Well Name: CORRAL 22-34 FED COM	Well Location: T25S / R29E / SEC 22 / NENW / 32.120346 / -103.974712	County or Parish/State: EDDY / NM
Well Number: 105H	Type of Well: OIL WELL	Allottee or Tribe Name:
Lease Number: NMNM14778	Unit or CA Name:	Unit or CA Number:
US Well Number: 3001556565	Operator: XTO ENERGY INCORPORATED

Notice of Intent

Type of Submission: Notice of Intent	Type of Action: APD Change
Date Sundry Submitted: 05/20/2025	Time Sundry Submitted: 01:55
Date proposed operation will begin: 05/26/2025

Procedure Description: XTO Energy Inc. respectfully requests approval to make the following changes to the approved APD. Changes include KOP, FTP, LTP, BHL, Proposed total depth, pool, and dedicated acreage, Formation TVD, Casing Design, Cementing Program, Mud Program. APD ID 10400098686; Well API: 30-015-56565 FROM: TO: KOP: 875' FNL & 1901' FWL OF SECTION 22-T25S-R29E 616' FSL & 1530' FWL OF SECTION 15-T25S-R29E FTP: 100' FNL & 1430' FWL OF SECTION 22-T25S-R29E 100' FNL & 1530' FWL OF SECTION 22-T25S-R29E LTP : 100' FSL & 1430' FWL OF SECTION 34-T25S-R29E 330' FSL & 1530' FWL OF SECTION 34-T25S-R29E BHL: 50' FSL & 1430' FWL OF SECTION 34-T25S-R29E 280' FSL & 1530' FWL OF SEC

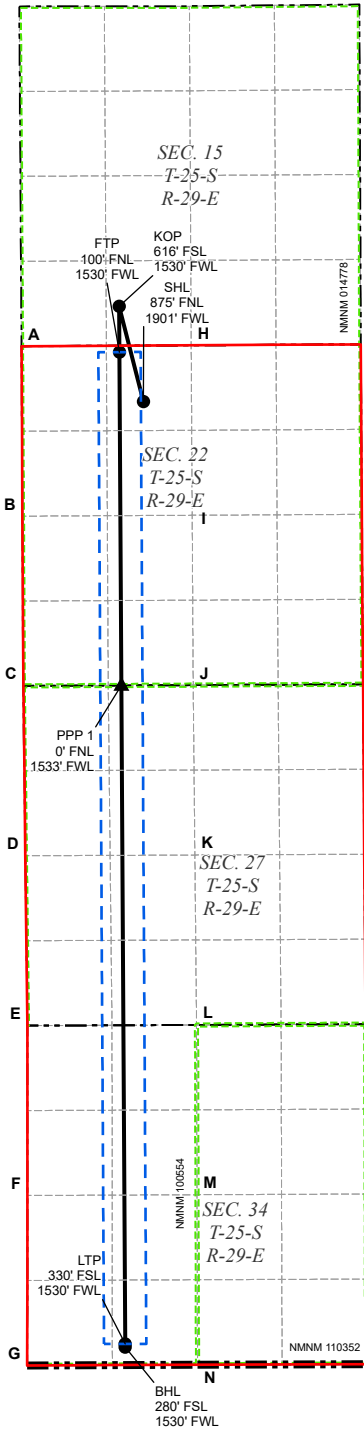
KOP: 875' FNL & 1901' FWL OF SECTION 22-T25S-R29E 616' FSL & 1530' FWL OF SECTION 15-T25S-R29E
FTP: 100' FNL & 1430' FWL OF SECTION 22-T25S-R29E 100' FNL & 1530' FWL OF SECTION 22-T25S-R29E
LTP : 100' FSL & 1430' FWL OF SECTION 34-T25S-R29E 330' FSL & 1530' FWL OF SECTION 34-T25S-R29E
BHL: 50' FSL & 1430' FWL OF SECTION 34-T25S-R29E 280' FSL & 1530' FWL OF SECTION 34-T25S-R29E

The proposed total depth is changing from 25299 MD; 8866 TVD to 26649 MD; 10421 TVD.

The pool is changing from WILLOW LAKE, BONE SPRING, SOUTHEAST to PURPLE SAGE; WOLFCAMP (GAS).

The dedicated acreage is changing from 960.00 to 1920.00.

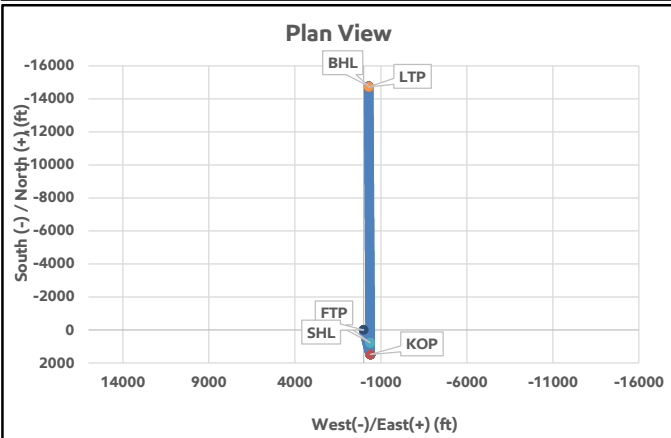
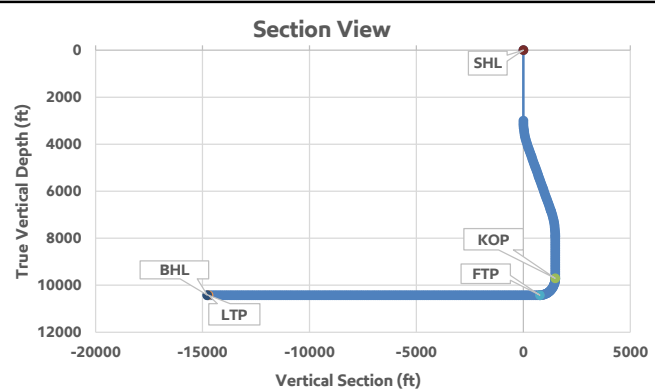
Inclination (°)	Azimuth (°)	True Vertical Depth (ft)	Y Offset (ft)	X Offset (ft)
SHL	0	0	0	0	0
KOP	0	0	9705	1489	-379
LP	90	180	10421	773	-375
FTP	90	180	10421	773	-375
LTP	90	180	10421	-14723	-287
BHL	90	180	10421	-14774	-287

XTO will keep casing fluid filled to meet BLM's collapse requirement.
The planned kick off point is located at: 9977' MD / 9705' TVD.
